## Exhibit 6

**From:** ex02@yuandacn.com [ex02@yuandacn.com]  
**Sent:** 7/20/2018 8:21:30 AM  
**To:** jdearth [JDeearth@WhitestoneCC.com]  
**CC:** charles\_tan [charles\_tan@126.com]; pcarvelas [pcarvelas@WhitestoneCC.com]; sgrzic [SGrzic@WhitestoneCC.com]; plepkowski [PLepkowski@WhitestoneCC.com]; ex02 [ex02@yuandacn.com]  
**Subject:** Re: RE: CUNY - Building movement @ WT-3 IMPORTANT  
**Attachments:** Check D312G D313G.pdf; D312G & D313G\_7-10-20.pdf; D312G & D313G\_7-10-20.dwg

**Check D312 G****LOAD DETAIL**

SUBJECT: WT-3 Canopy

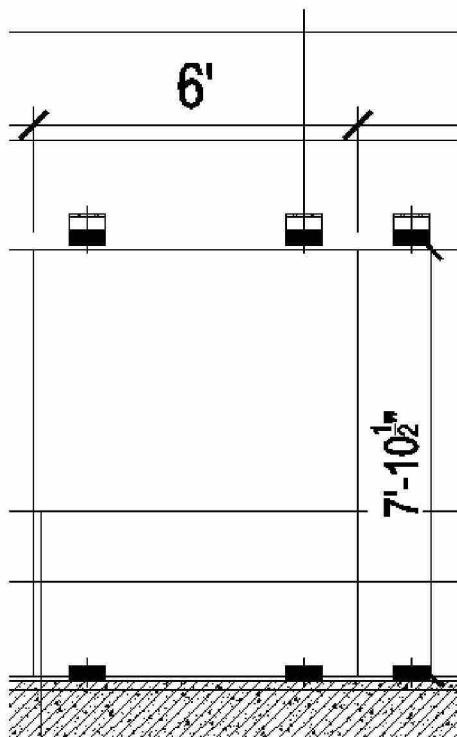
The calculation is completed, it is OK, but there are some points need to be noted:

- a. Aluminum block should be added in AL51 profile, its size is 11/16 "\*"1/4", the material is 6063-T6, the same length as aluminum angle, and AL51 should be fixed together with the aluminum block with countersunk head screw.
- b. Aluminum angle, material should be 6063-T6.
- c. The method to fix the stainless steel plate and aluminum angle has been changed to stainless steel rivets, so as not to affect the fixation of gasket, which has been changed in the detail drawing.
- d. We found find a kind of gasket that is close to the requirement. I have put it in the detail for your reference.

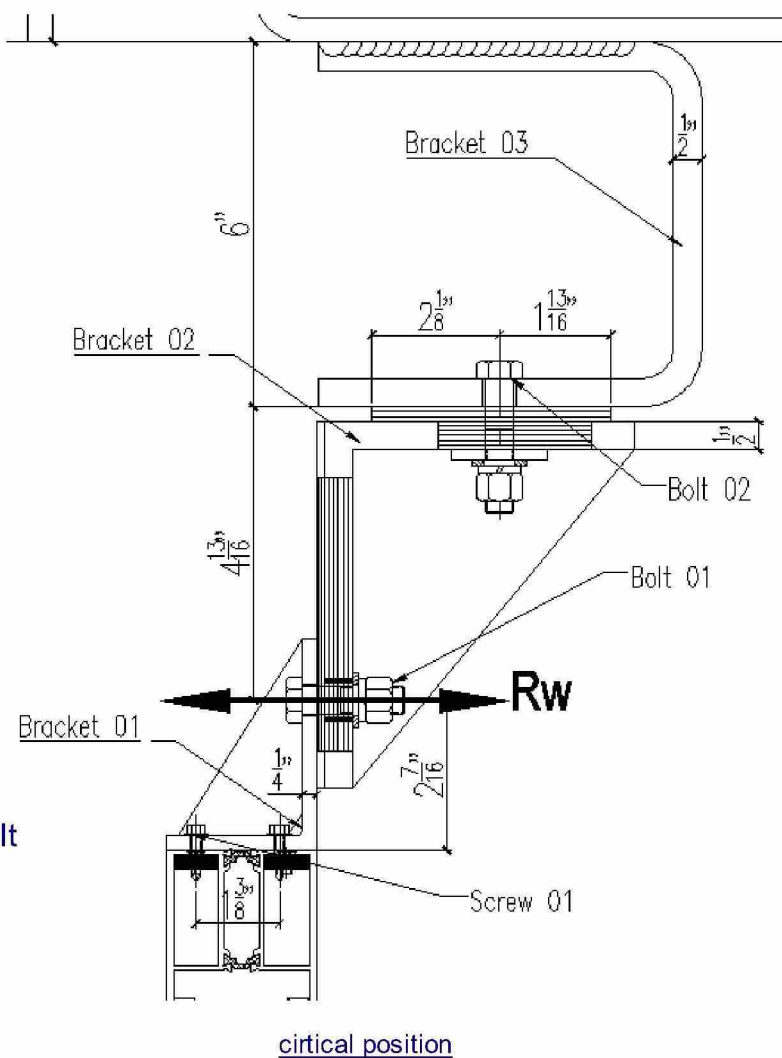
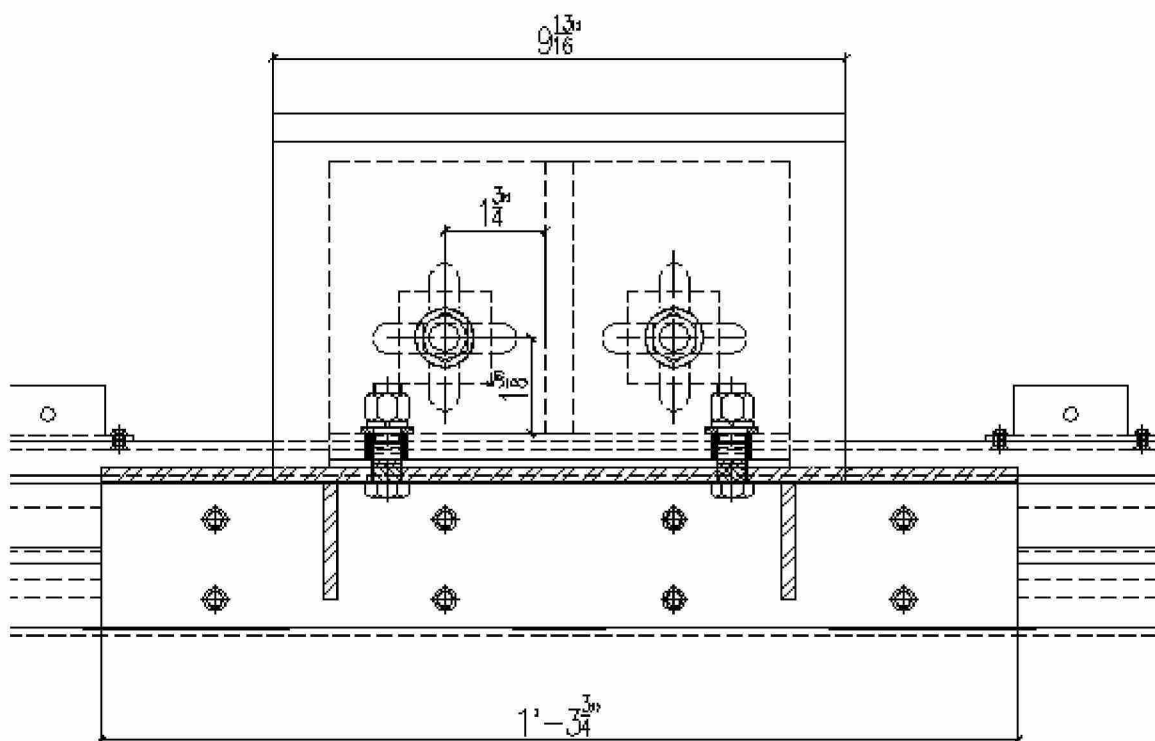
**Check Bolt 01**

$$f_{t1} := R_w \cdot \frac{1}{2} = 177 \text{ lbf}$$

Allowable tension force of 1/2" bolt

$$F_t := 5676 \text{ lbf} \quad \frac{f_{t1}}{F_t} = 0.031$$

Bolt 01 checked OK

Check Screw 01

$$f_{t1} := \frac{R_w \cdot 2 \frac{7}{16} \text{ in}}{1 \frac{3}{8} \text{ in}} \cdot \frac{1}{4} = 157 \text{ lbf}$$

$$f_{s1} := \frac{R_w}{2.4} = 44.297 \text{ lbf}$$

Allowable tension force of #10-24 screw

$$F_t := 584 \text{ lbf} \quad \frac{f_{t1}}{F_t} = 0.269$$

Allowable Shear force of #10-24 screw

$$F_s := 292 \text{ lbf} \quad \frac{f_{s1}}{F_s} = 0.152$$

$$\left( \frac{f_{t1}}{F_t} \right)^2 + \left( \frac{f_{s1}}{F_s} \right)^2 = 0.095 < 1 \text{ Screw 01 checked OK}$$
